CHAPTER 10: PUBLIC COMMENT AND RESPONSE

Western Area Power Administration (Western) involved a range of agencies, Tribes, and public constituencies in review of the Grapevine Canyon Wind Draft Environmental Impact Statement (Draft EIS). To prepare, postcards were mailed or emailed to approximately 350 entities prior to the issuance of the Draft EIS to ask if and how they would like to receive the Draft EIS. Upon issuance of the Draft EIS, the U.S. Environmental Protection Agency published a Notice of Availability (NOA) for the Draft EIS in the Federal Register on July 23, 2010 (Vol. 74, No. 141, page 43161). The NOA also announced a 45-day comment period for receipt of comments. Locally, Western published a display ad and Coconino National Forest (Forest) published a legal notice in the Arizona Daily Sun with the NOA information, and announcements of two public hearings held on August 17 and 18, 2010, in Mormon Lake and Flagstaff, respectively. Western also provided notification of the issuance of the Draft EIS and the hearings to entities with email addresses. Compact discs and/or hard copies of the document were mailed to 108 agencies, Tribes, organizations, and individuals. Cop

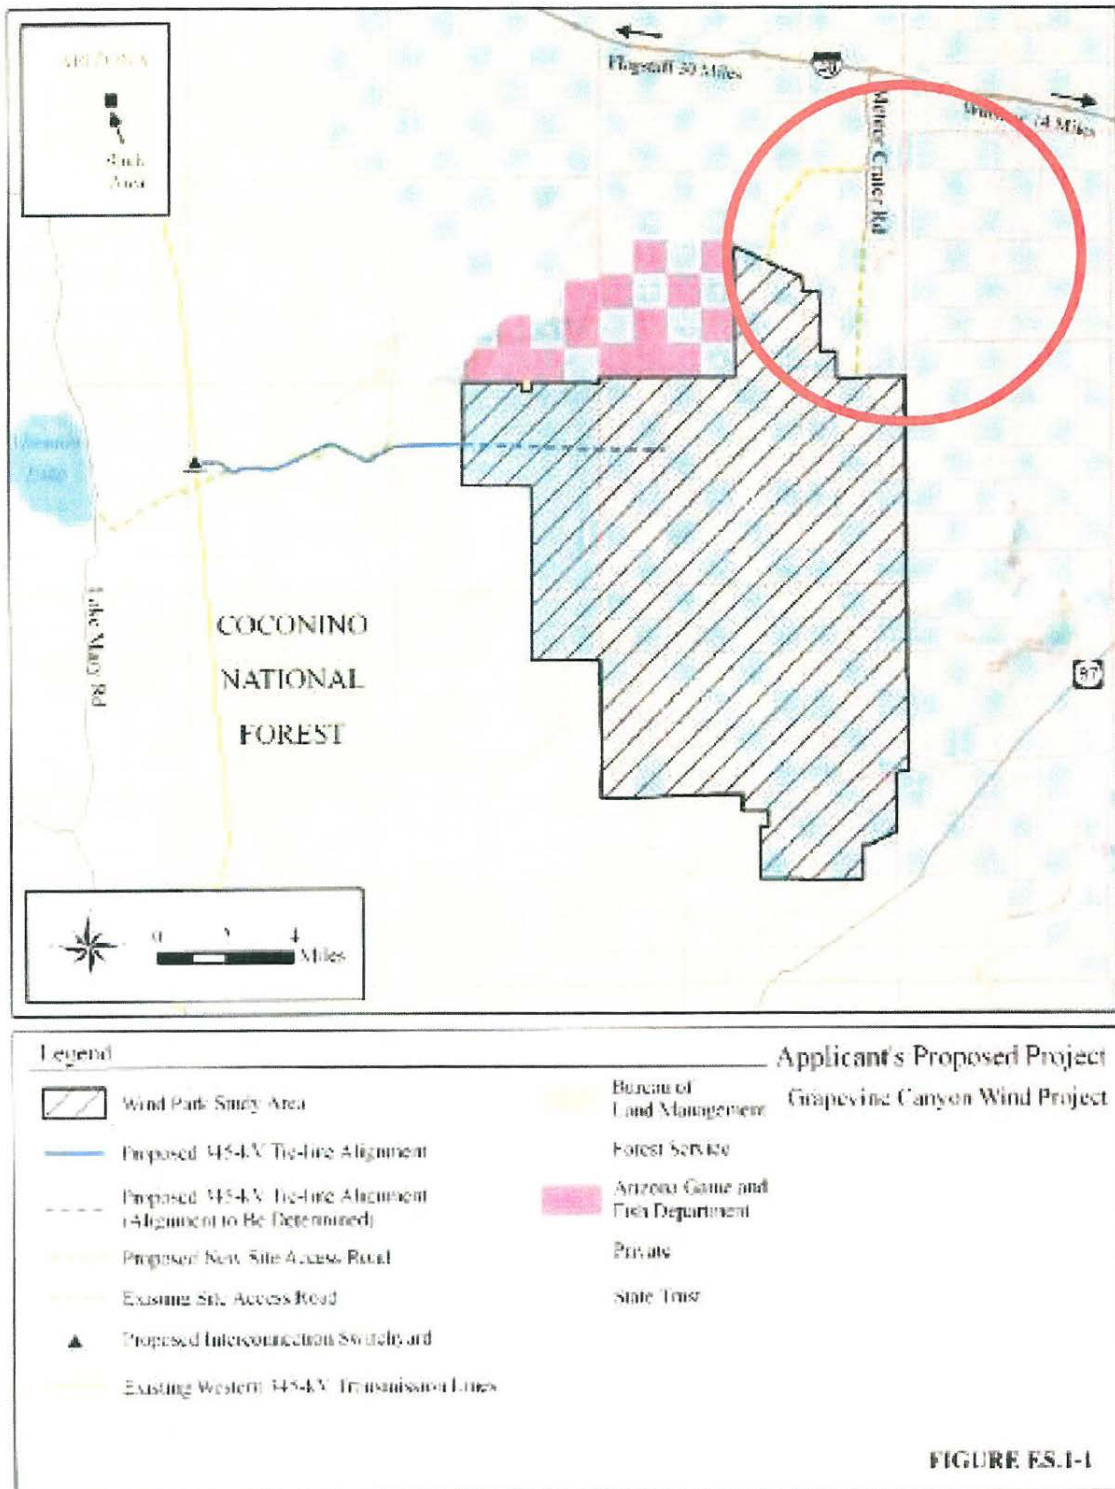
I have included the map of the study area that shows the area of concern inside a red circle. If the turbines are located 5 miles or more from our location, our visitor's experience would not be greatly affected because the intrusion into the view shed would be much less. We would however strongly object to turbines being built at a distance less than 5 miles from Meteor Crater.

Comment No.	Comment	Revisions at	Response
VISUAL RESOURCES			
B-1.1	The commenter has no objection to the project overall, but having wind turbines extending 250–300 feet over the rim of Meteor Crater within just two or three miles would be very distracting to its visitors. Meteor Crater is a National Natural Landmark, and people come from all over the world to visit our location. When viewing the Crater, visitors are typically looking south or west. Having turbines on land that is within five miles south and west of Meteor Crater would be detrimental to the visitor's experience and could negatively affect our business. If turbines are located five miles or more from the location, the visitor experience would not be greatly affected because the intrusion into the viewshed would be much less.	Section 3.12.2.2	<p>The Draft EIS notes that Meteor Crater is a National Natural Landmark designated by the National Park Service, and evaluates Meteor Crater visual resources and the potential for the project to impact visitors' experience. In evaluating impacts, the Draft EIS focused on views of the wind park from the Visitor Center patio and the rim of the crater that would experience minor and moderate adverse impacts, respectively.</p> <p>The relevant standard is the Coconino County Comprehensive Plan, Diablo Canyon RPA goal: “<i>Facilitate the development of alternative energy projects while maintaining the integrity of the ranches and preserving aesthetics and views.</i>” This goal is further defined by the policy that wind projects “<i>shall be located at least one mile from major travel corridors, such as I-40 and SR 87.</i>” The proposed project is consistent with this County goal. The EIS concludes that the permanent change created by introducing broad visual contrast into the natural landscape is an adverse impact that is minor to moderate (depending on the location of the viewer) and unavoidable. However, the changes that will occur with the wind park would not result in a deterioration of natural values on which the landmark designation is based. While the wind park would change the views at middle (0.5 to 4 miles) and background (beyond 4 miles) distances, the WTGs are not within the Meteor Crater boundaries and do not change the geologic features of the site. In addition, the WTGs locations and distance from the Meteor Crater are such that they would not be noticeable in the foreground views. In summary, Western determined that the WTGs would change the views from the site, but would not significantly impact the visitor’s experience because the visitor’s focus is on the crater itself and its history and geology. While visitors may enjoy the middle and background views from the site, those are not the primary features of the site. Finally, Foresight will consult with the management of Meteor Crater Enterprises during final design of the wind park to minimize visual impacts to middle and background views to the extent feasible.</p>
